CHAPTER 3

Comments and Responses

3.1 Comments on the Draft EIR and Responses

This section contains all comment letters and responses to comments. Each comment letter is assigned an alphanumeric code, from A1 through C40, and each comment is numbered in the margin of the comment letter. Responses to the comments follow each letter, and responses are referenced using the same alphanumeric system. For example, the first comment from the first letter, from the National Oceanic and Atmospheric Administration, is designated A1-1, as is the response to it. Testimony from the public hearing is assigned the code “PH” and follows the comment letters.

Figure 3-14b
Water Surface Elevation Change With Project
25 - Year Flood Event: Upper San Anselmo

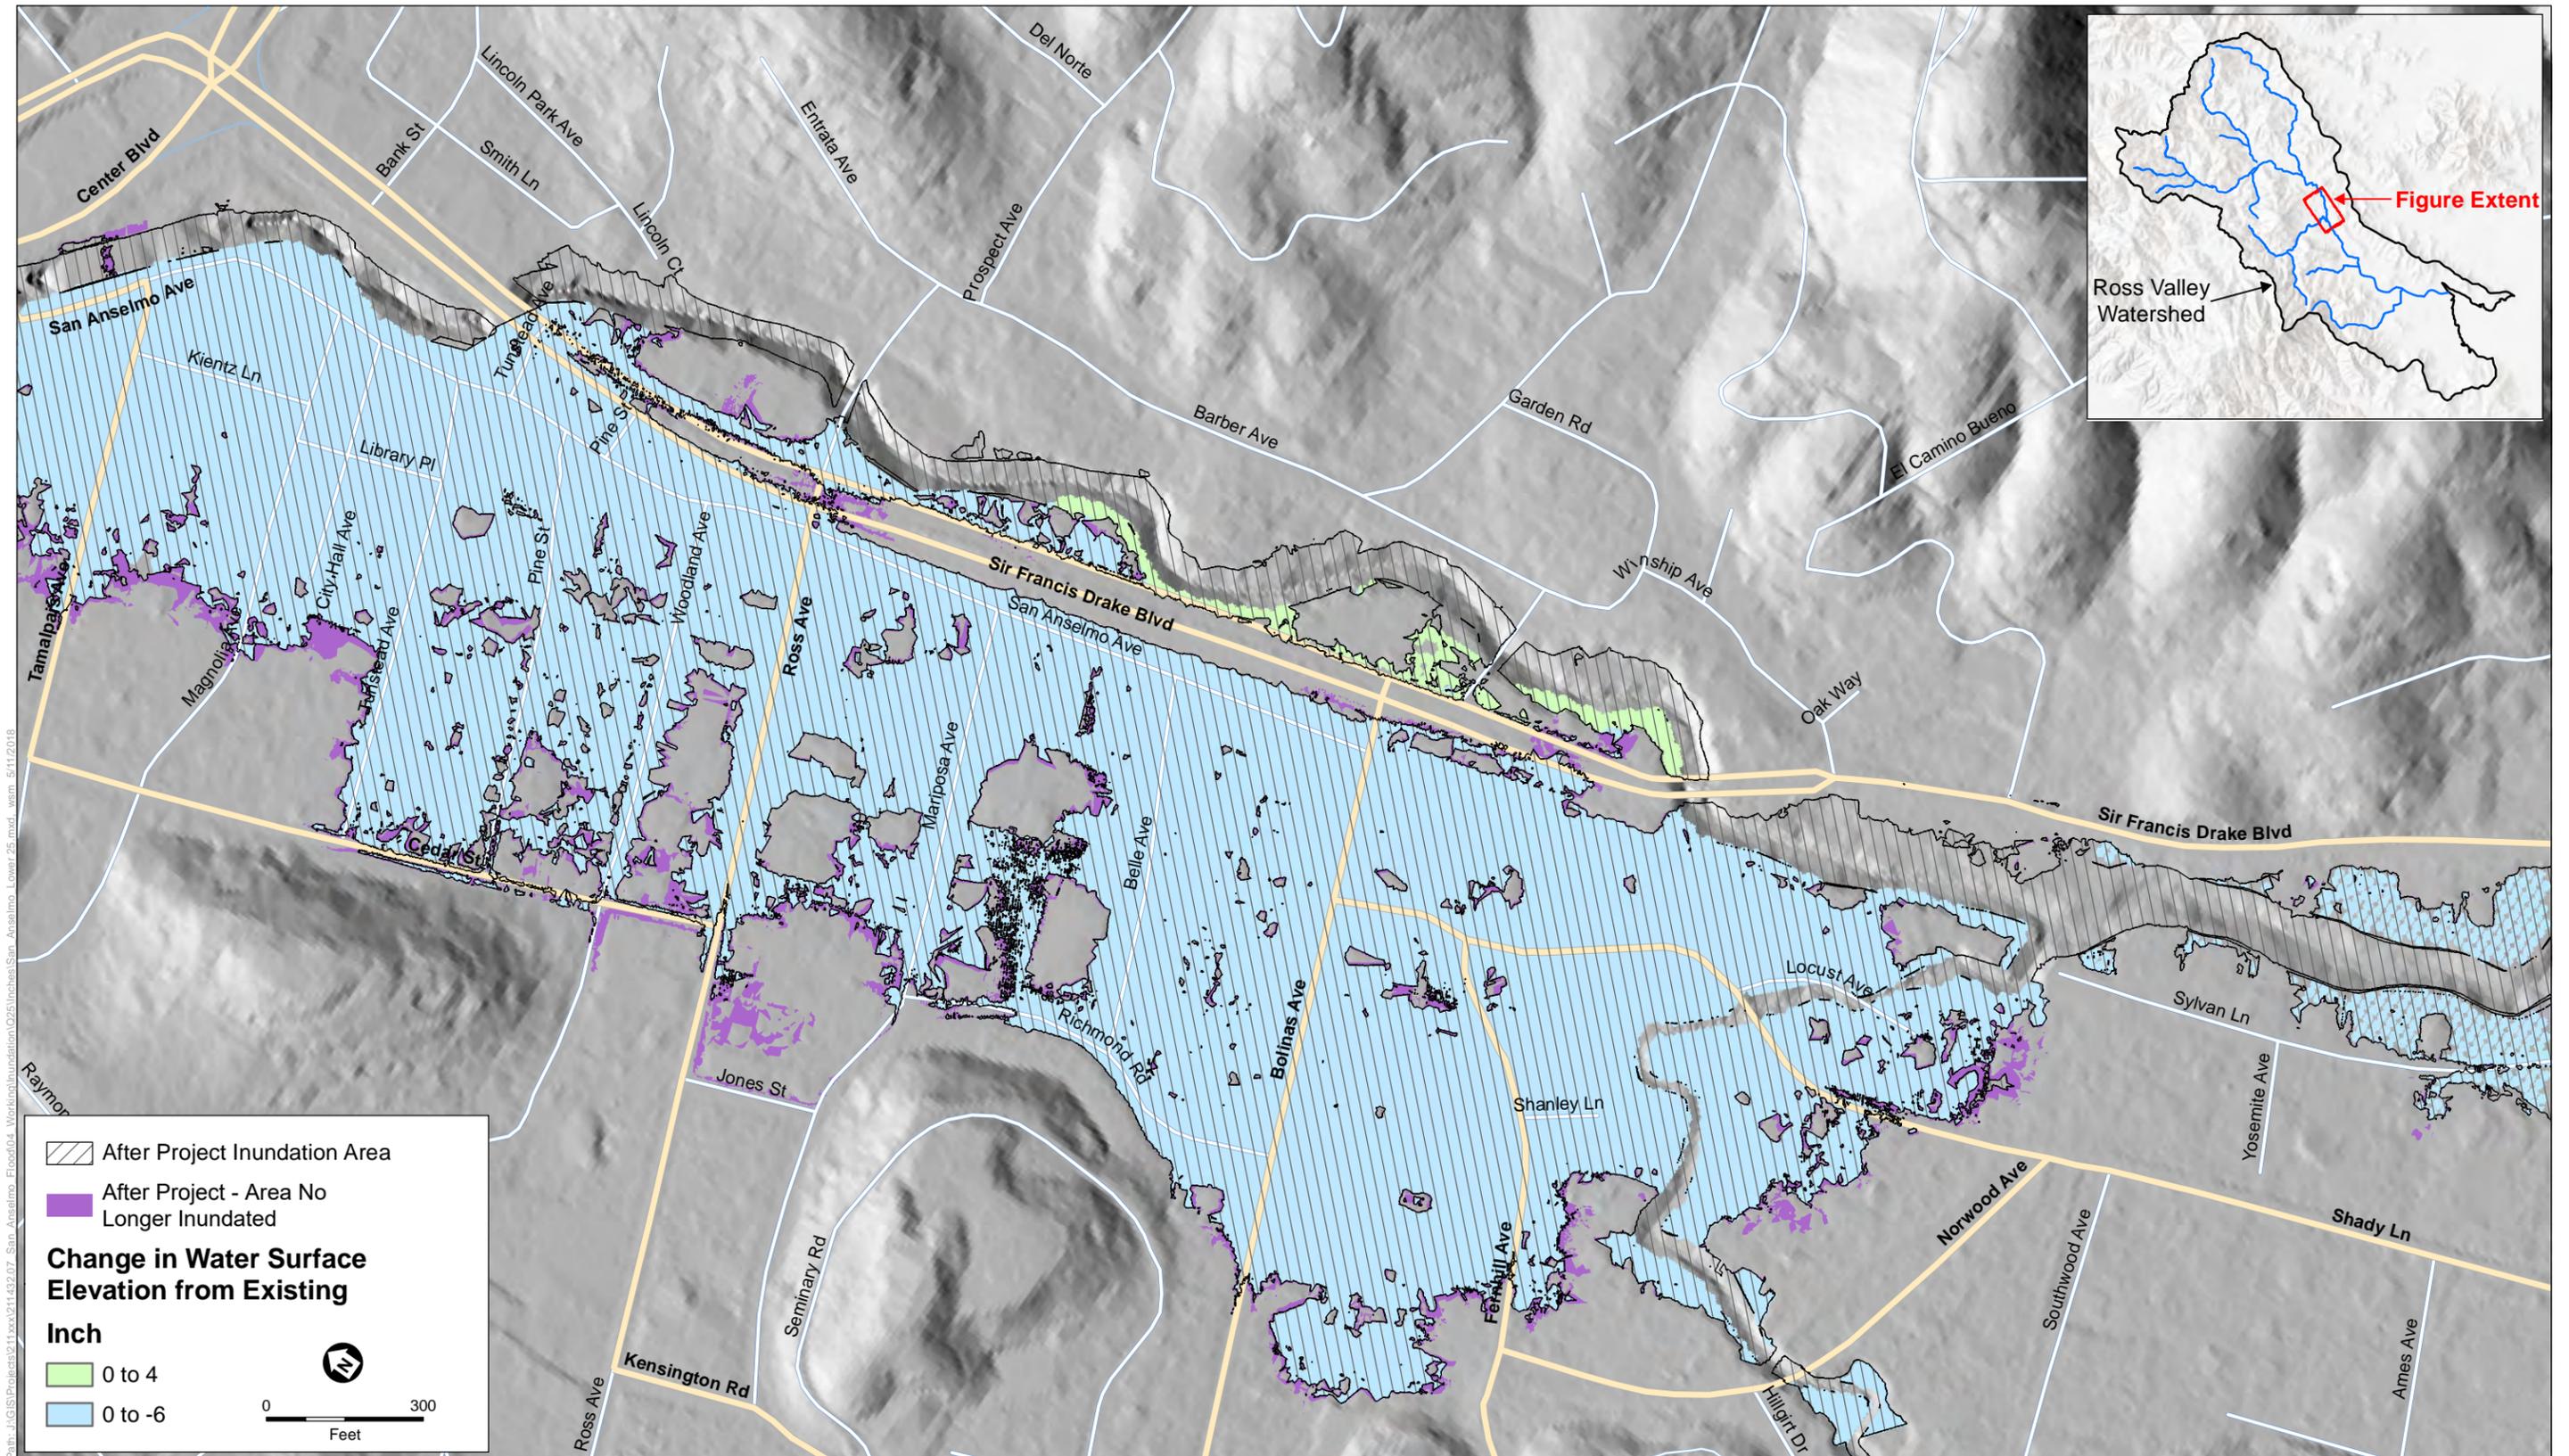
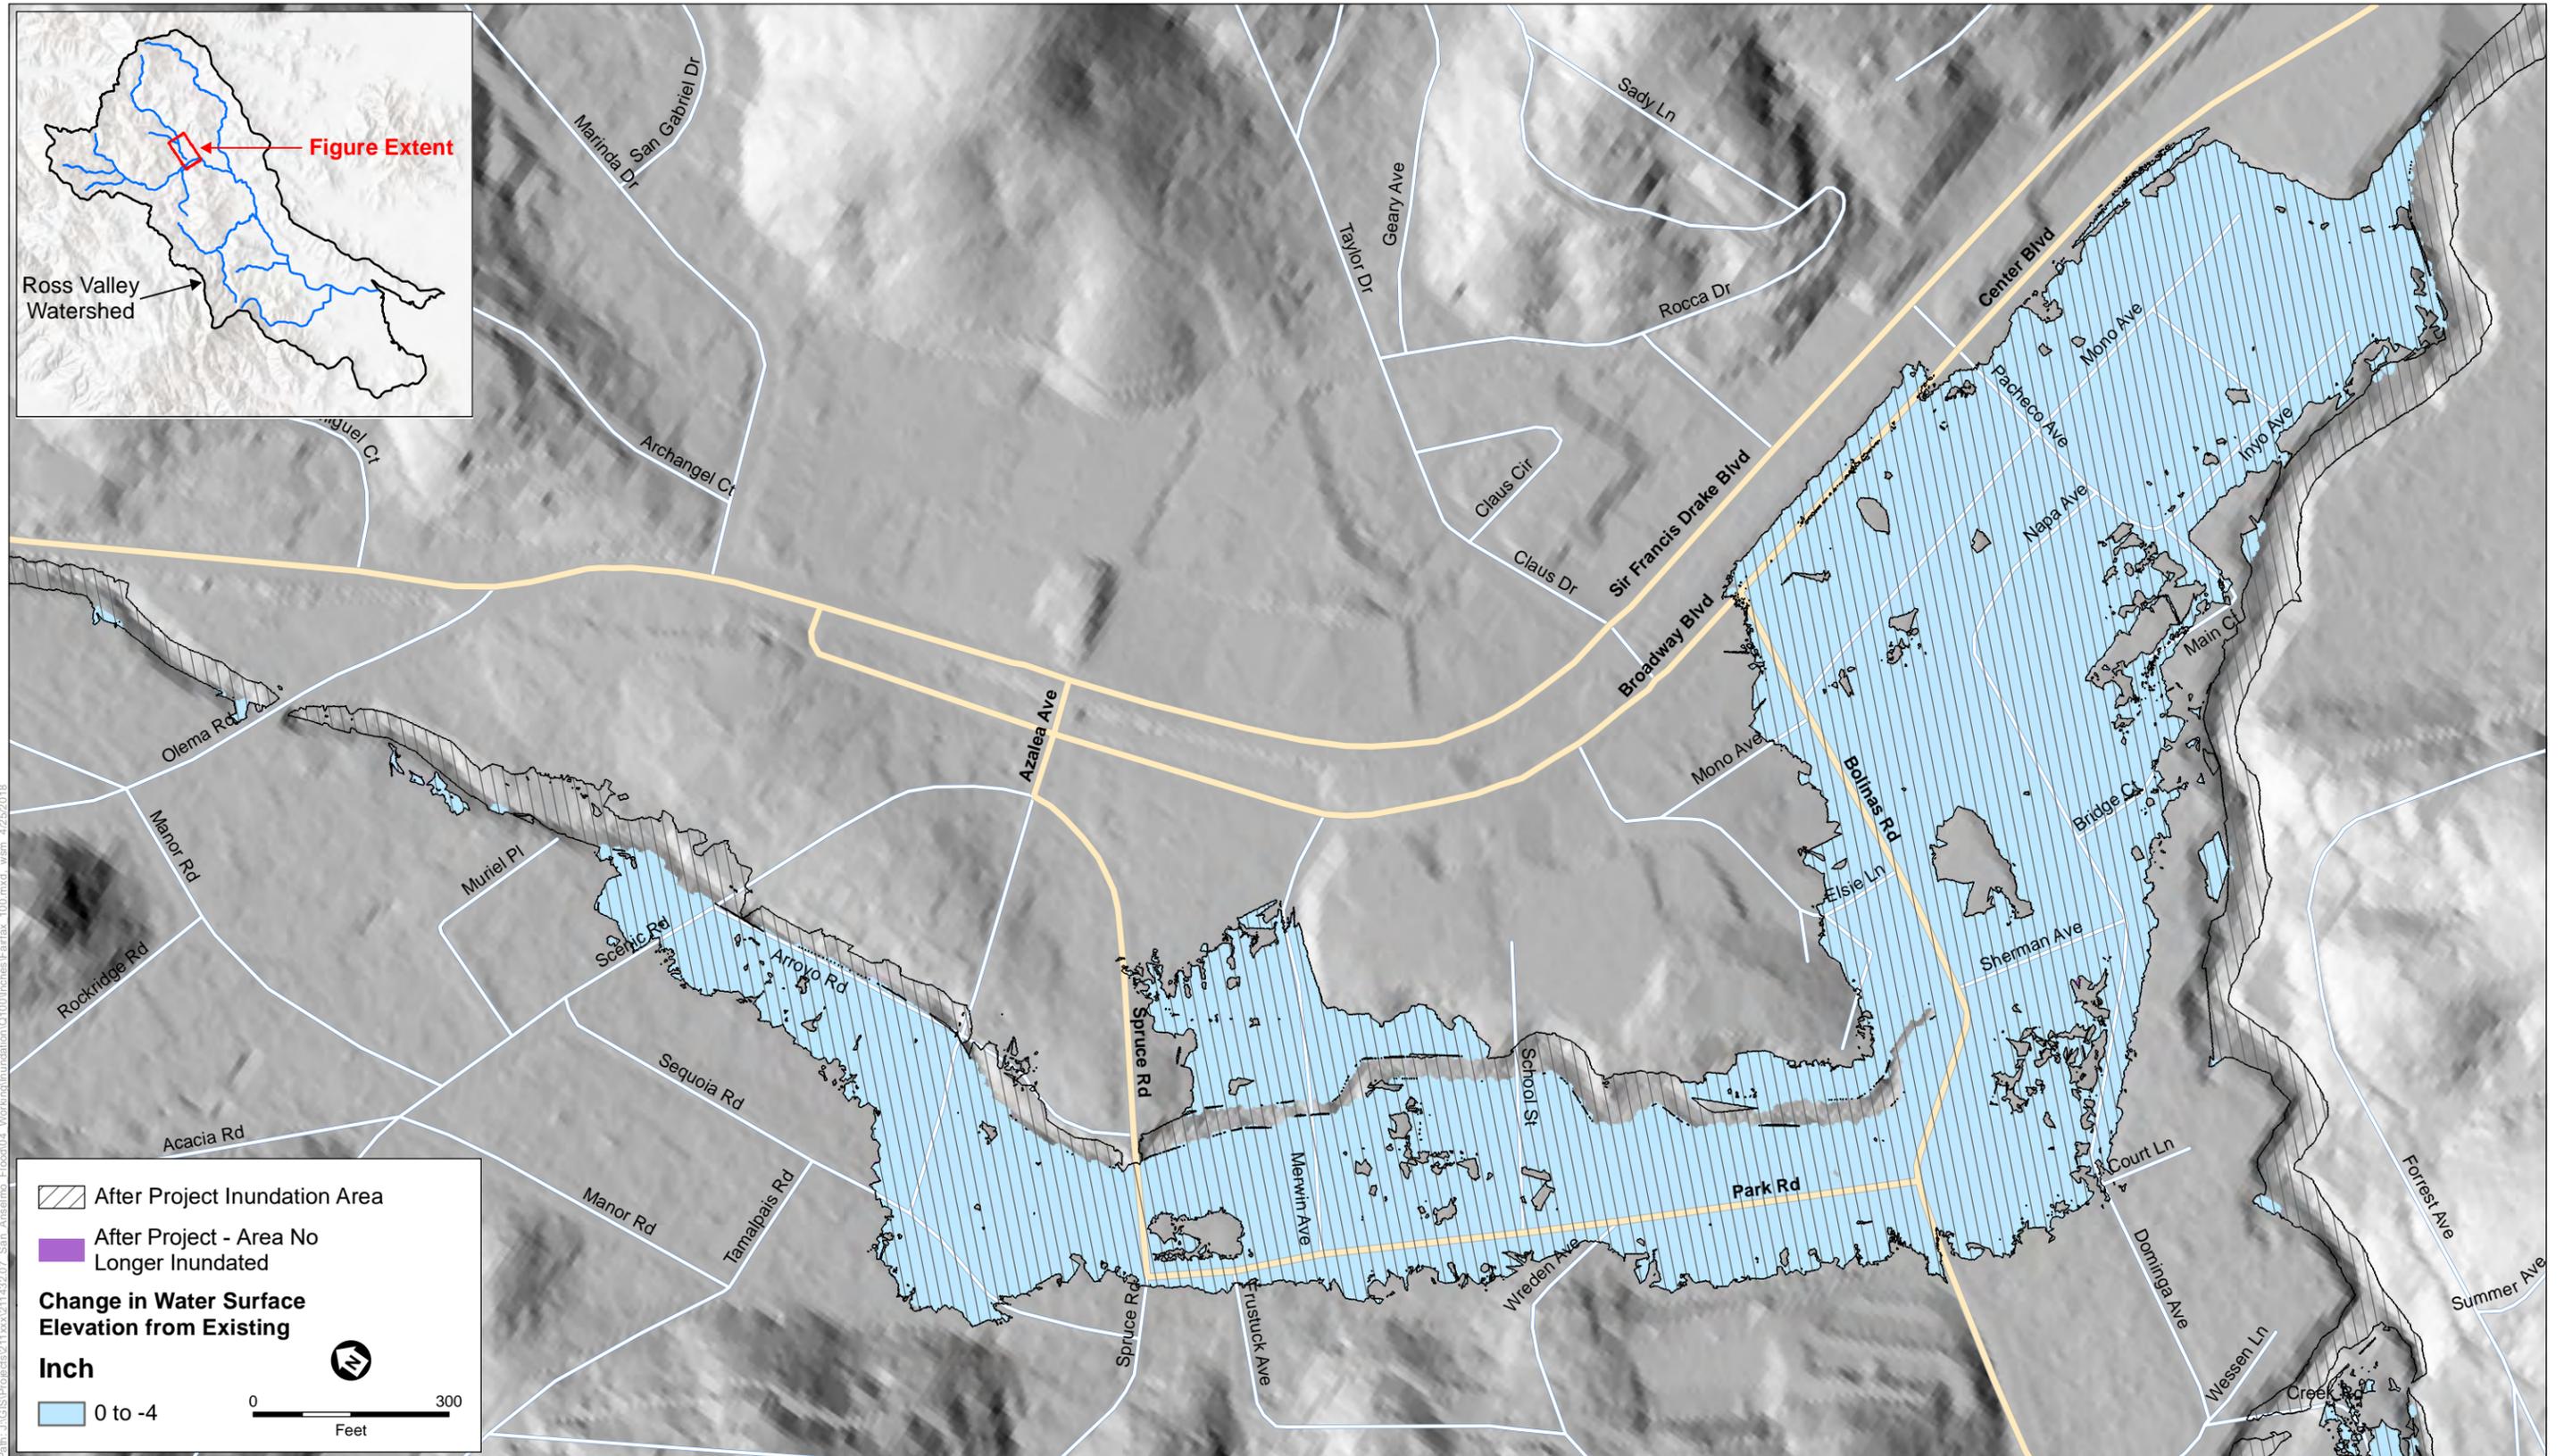
Figures in Chapter 3 (figures 3-13, 3-14, and 3-15), that show water surface elevation, change with project are not easy to interpret. It appears that the purple areas, labeled "After Project Inundation Reduction Area" would be removed from flooded areas during the specified events. However, use of the word "reduction" suggests that they would still be inundated, just to a lesser extent.

Draft EIR Figures 3-13a-c, 3-14a-c, and 3-15a-c have been revised in response to this comment. The revisions to these figures do not result in any changes to the environmental analysis in the Draft EIR.

In response to Comments B1-5 and PH-2, the legend descriptions associated with purple areas of Draft EIR Figures 3-13a-c, 3-14a-c, and 3-15a-c (Draft EIR pages 3-25 through 3-33) have been revised to read:

After Project ~~Inundation Reduction Area~~ – Area No Longer Inundated
